PLANNING COMMISSION
SITE/SUBDIVISION PLAN
CASE SUMMARY

4.6 ACRES, 100, 200 AND 300 BLOCKS OF NORTHWOOD STREET
CANAL PLACE PHASE 2D3

Subject Property:	4.6 acres, 100, 200 and 300 Blocks of Northwood Street, TMS#09004-04-34, 09004-04-36 thru 61, 09101-01-08 thru 39
Council District:	2
Proposal:	Request site plan review of an 63 lot single-family residential cluster housing development (Canal Place Phase 2D3)
Applicant:	Howard Boyd, II, PE, Southeastern Land Management & Surveying, LLC
Proposed Use:	Single-family Residences
Recommendation:	Approval with staff comments.

SITE PLAN OF
CANAL PLACE PHASE II D3

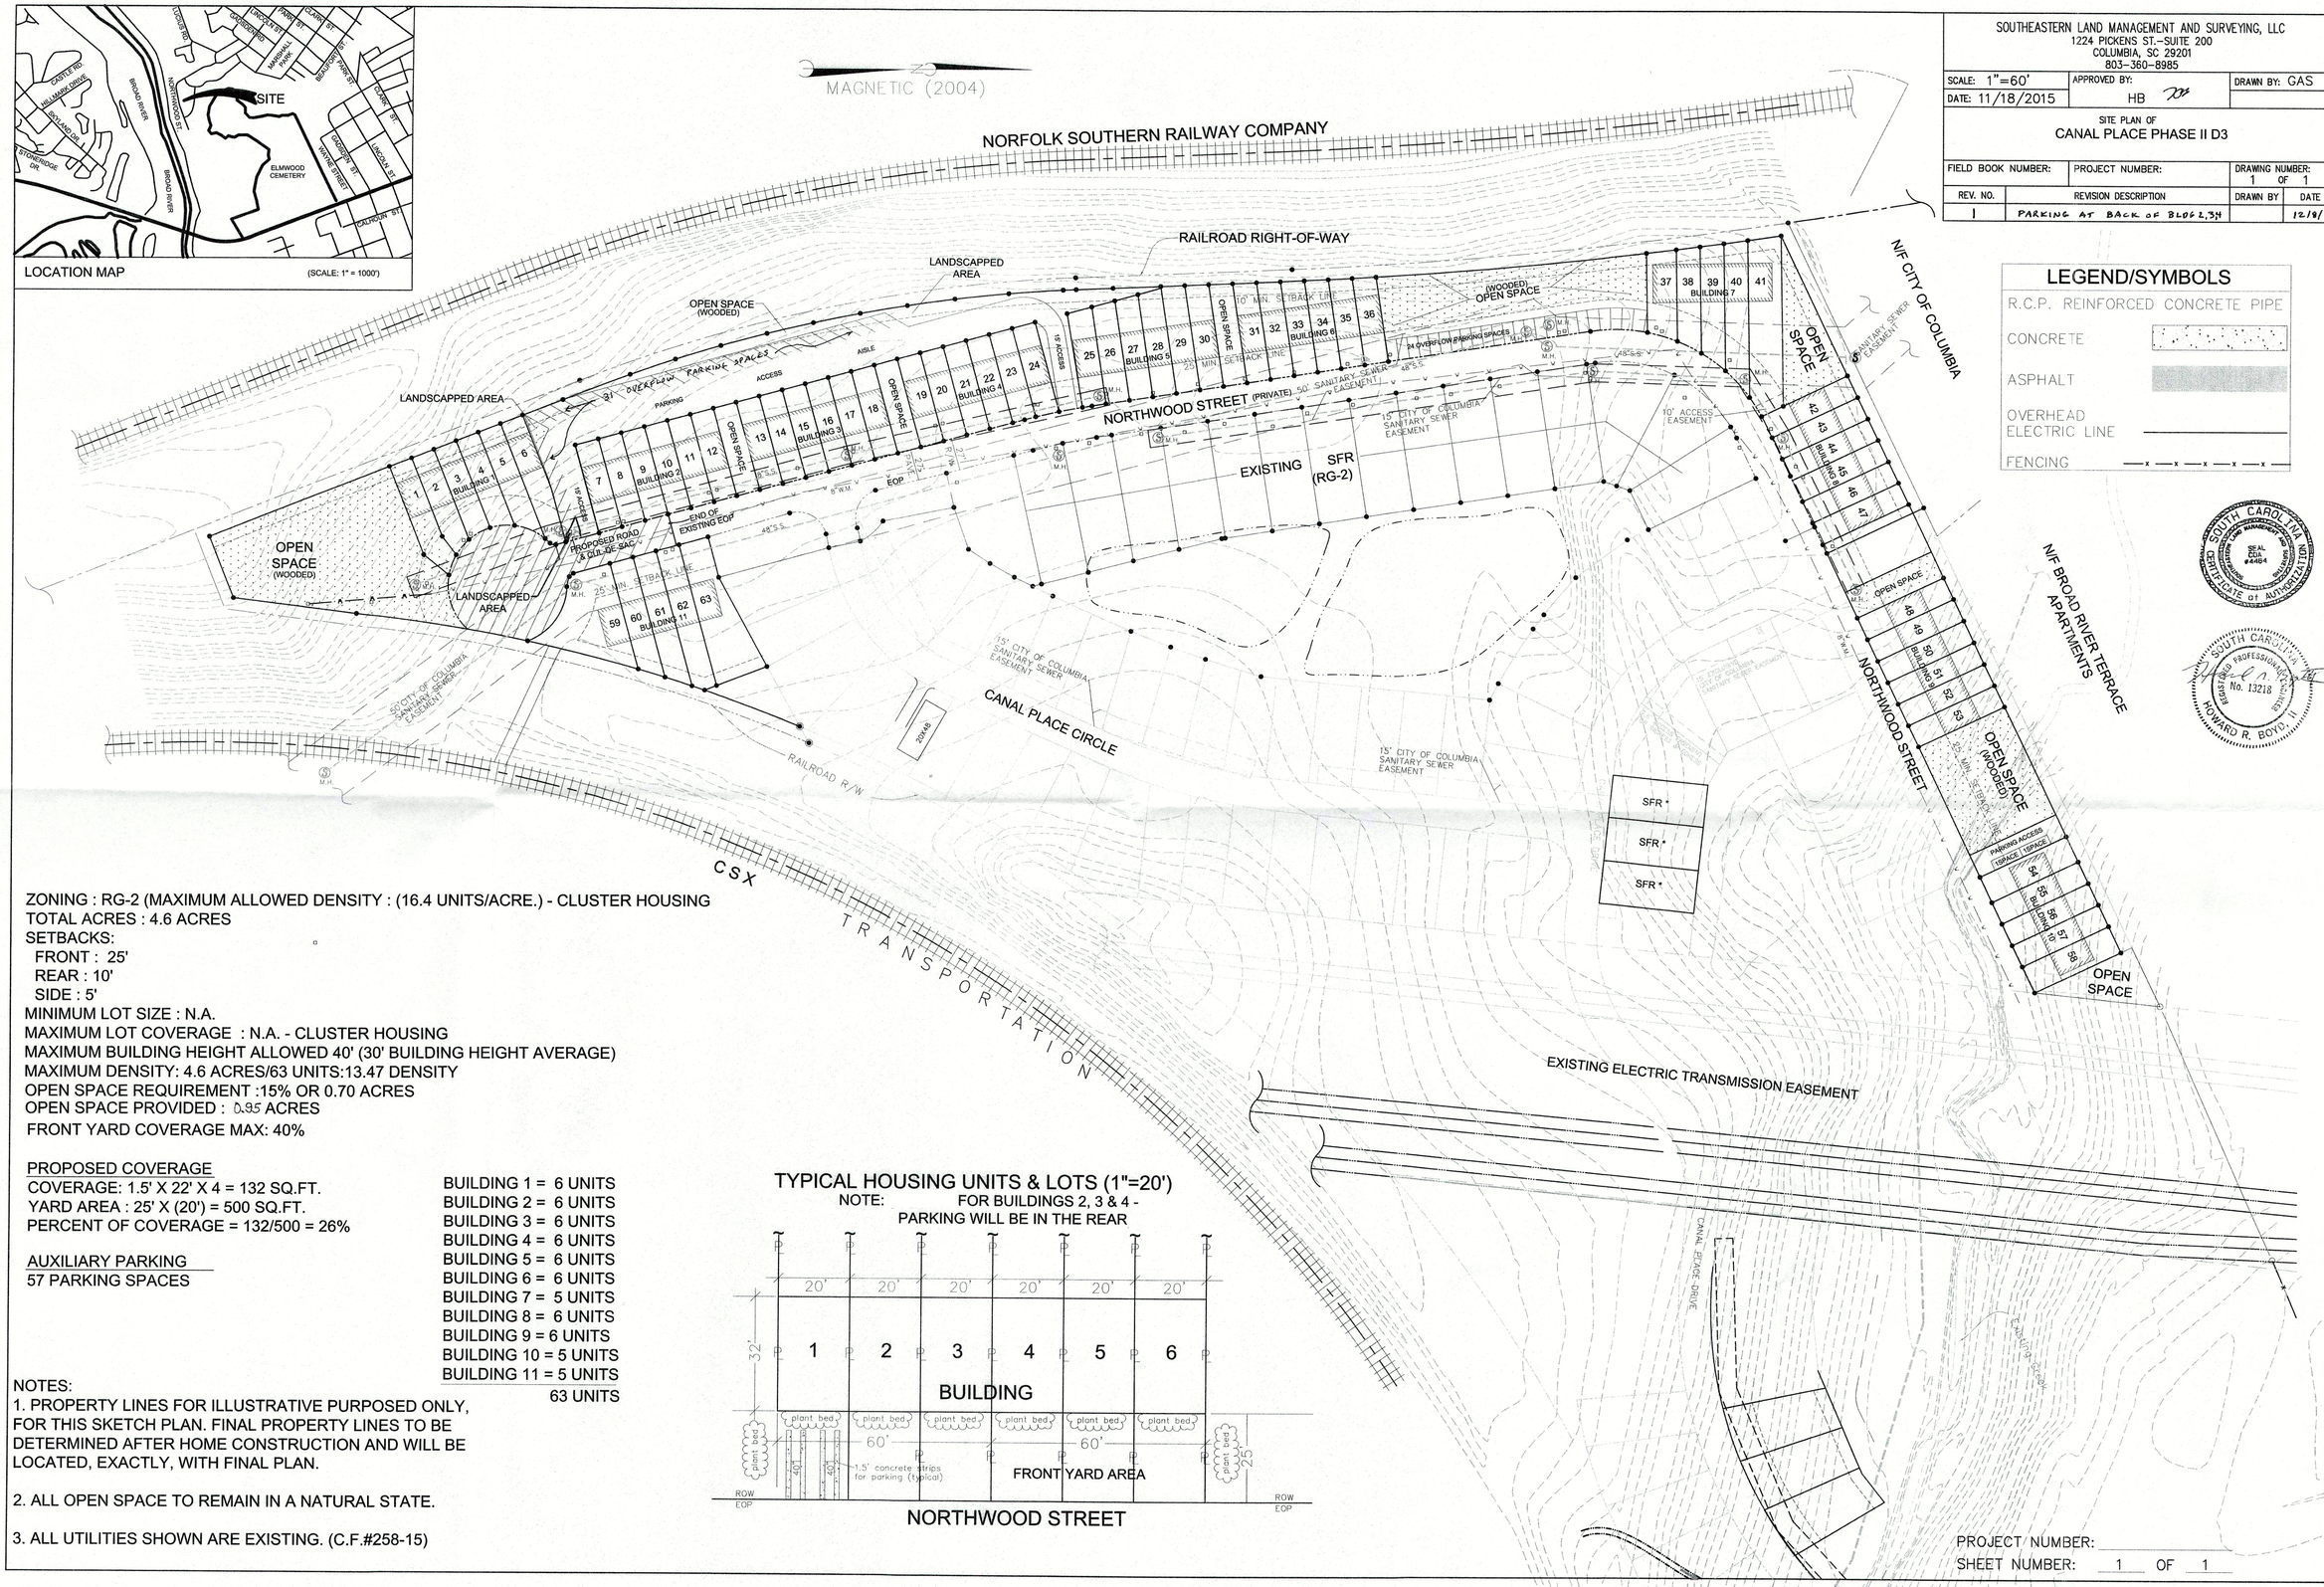
CITY AGENCY COMMENTS FOR SITE/SUBDIVISION PLAN REVIEW	
John Fellows, Planning	**Recommend approval.**
K. Brian Cook, Zoning Administrator	**Recommend approval.**
Johnathan Chambers, Land Development Administrator	**Recommend approval.**
Robert Harkins, Plans Examiner	**Recommend approval.**
Scott Rogers, Utilities	**Recommend approval with conditions:** 1. Any needed upgrade, extension or relocation of City utilities must be provided by the developer. 2. Any privately owned/maintained utilities or permanent structures cannot be located inside City of Columbia utility easements. 3. Water mains, sewer mains, water meters that are 4" or larger or any privately maintained utilities will not be allowed inside public right-of-ways or under sidewalks without an approved encroachment permit and written approval from the City Engineer. Coordination between the Civil Engineer, Architect and Mechanical Engineer to allow room for these utilities on the developed property is strongly encouraged.

4. If sewer flows for this project result in flows of 4,000 gallons per day or above calculations must be submitted to the City's Engineering department to determine how the proposed project will affect the City's sewer system. Depending upon the effects of the projected flows this project may or may not be approved. If required, these calculations should be submitted to the Engineering department as soon as possible.
David Brewer, Traffic Engineering	**Recommend approval.**
David Koon, Fire Department	**Recommend approval.**
Scott Holder, Land Development Planner	**Recommend approval with conditions:** 1. Removal of Grand Trees require permission from Zoning Administrator. 2. Replacement of grand tree units is above and beyond density factor for site. Existing trees used to offset units from removed trees will need to be accounted for on a survey.
Sara Hollar, Forestry	**Recommend approval with conditions:** 1. If any new landscaping or irrigation is installed in the right of way, it must be approved by Forestry and Beautification and maintained by the adjacent property owner in a manner to not interfere with vehicular and pedestrian traffic. 2. SCDOT must approve any new landscaping installed along SCDOT roadways.

Michael Jaspers, Stormwater	**Recommend approval with condition:** 1. If land disturbance is equal to or greater than 5,000 sq. ft. for this project, or larger common plan, all applicable land disturbance requirements must be followed.
Robert Sweatt, Street	**Recommend approval with condition:** 1. Ensure all current ADA requirements for cross and running slope are met at driveways.
John Hooks, Solid Waste	**Recommend approval.**
John Spade, Parking	**Recommend approval.**
